**Public Comment No. 824-NFPA 70-2021 [Global Input]**

First Revision No. 7641-NFPA 70-2020 [Global Input]

Figure Figure Informational Note Figure 100.1 Clothes-Closet Storage Space.

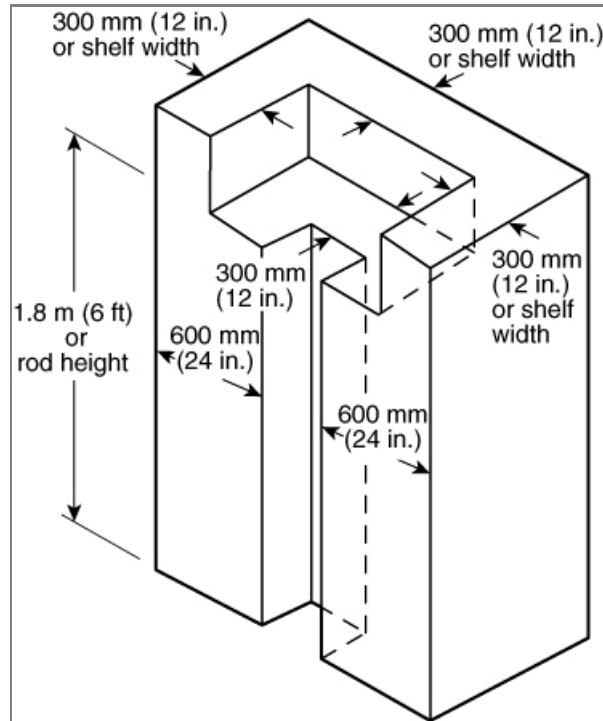
This drawing is a collection of requirements (every measurement being a requirement) and not a definition. it should remain in Article 410.

Statement: The contents and figure are moved to 410.16 to comply with NEC Style Manual. The changes to the definition provide simplification and clarity.

Figure Figure Informational Note Figure 100.1 Clothes Closet Storage Space.

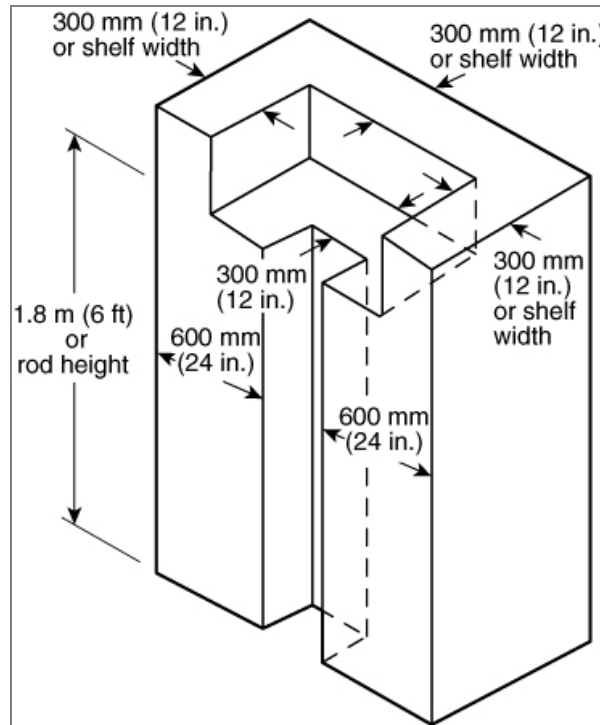
This comment was prepared by a CMP-18 Definitions Task Group consisting of the following members: B. Fahey, C. Kurten, F. Carpenter, J. Potterf, M. O'Boyle, P. Costello, R. Wright, R. Alley. Pursuant to the Technical Correlating Committee direction, the task group reviewed this definition and recommend the suggested changes to align the definition with the NEC Style Manual. The content, including the figure, should be moved to 410.16 as suggested by a companion comment. The suggested changes to the definition provide simplification and clarity.

Committee Action: Rejected but see related SR
Resolution: [SR-8119-NFPA 70-2021](#)
Statement: The contents and figure are moved to 410.16 to comply with NEC Style Manual. The changes to the definition provide simplification and clarity.
